Winnebago Industries, Inc. has started a recall campaign.

SUBJECT: Campaign #111 – Vehicle Certification Label

INSTRUCTIONS TO PERFORM CAMPAIGN 111

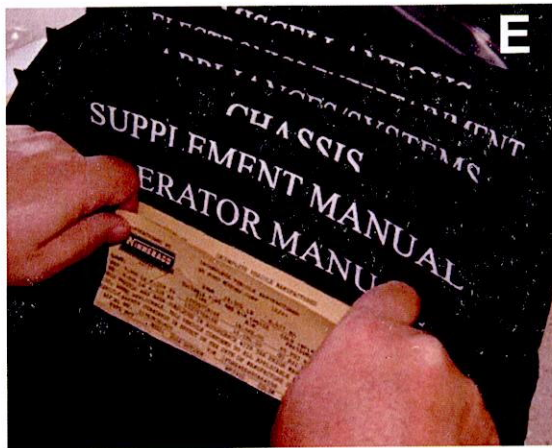
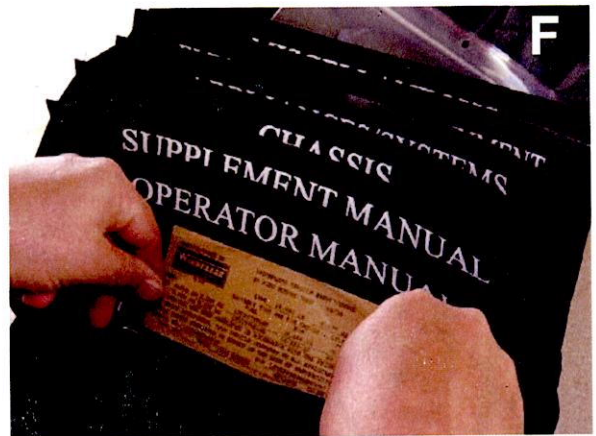
1. Cover the existing Vehicle Certification Label below the driver's window with the corrected label included with this campaign and cover with the protective clear adhesive overlay as shown in Photos C and D.
